Access Compliance Report

Public Rights-of-Way

(Curb Ramps)

Intersection ID: 48433	Main Street: WHITHORN_WY	Cross Street: SEAMILL_RD	Location: SE
ADA ID: 9E1D23CE03FC	Ramp Type: PerpDiag	Initial Pass/Fail: Fail	Overall Compliance: No
Codes/Mitigation Info/Possible Solution		Field Measurements/Component Compliance	
Severity Score: 13.75

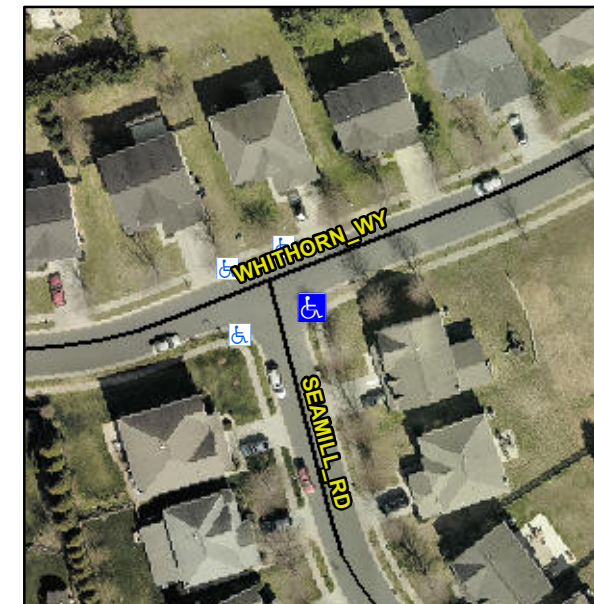
R304.2.2, R304.5.3

Compliance	Description	Data	Compliance	Description	Data
N/A	Ramp Length (in)	49.0	No	Ramp Slope (%)	11.1
Yes	Ramp Width (in)	48.0	No	Ramp XSlope (%)	4.9
N/A	Flare Type LT	N/A	N/A	Flare Type RT	N/A
N/A	Flare Slope LT (%)	N/A	N/A	Flare Slope RT (%)	N/A
N/A	Flare Traversable LT?	N/A	N/A	Flare Traversable RT?	N/A
N/A	Landing Length (in)	N/A	N/A	DWS Provided?	N/A
N/A	Landing Width (in)	N/A	N/A	DWS Contrast?	N/A
N/A	Landing Slope (%)	N/A	N/A	DWS Length (in)	N/A
N/A	Landing X Slope (%)	N/A	N/A	DWS Full Width?	N/A
N/A	Landing Curb? (Y/N)	N/A	N/A	DWS Offset (in)	N/A
N/A	Shared Landing?	N/A			
N/A	Gutter Ponding?	N/A	N/A	Gutter Slope (%)	N/A
N/A	Gutter Lip Ht (in)	N/A	N/A	Gutter X Slope (%)	N/A
N/A	Painted X Walk1?	No	N/A	Painted X Walk2?	No
	X Walk 1 Direction	To N		X Walk 2 Direction	To W
N/A	X Walk 1 Width (in)	N/A	N/A	X Walk 2 Width (in)	N/A
	X Walk 1 Slope (%)	2.3		X Walk 2 Slope (%)	0.2
	X Walk 1 X Slope (%)	2.8		X Walk 2 X Slope (%)	1.1

Remove & Replace Curb Ramp With Two New Directional Ramps or Equivalent.
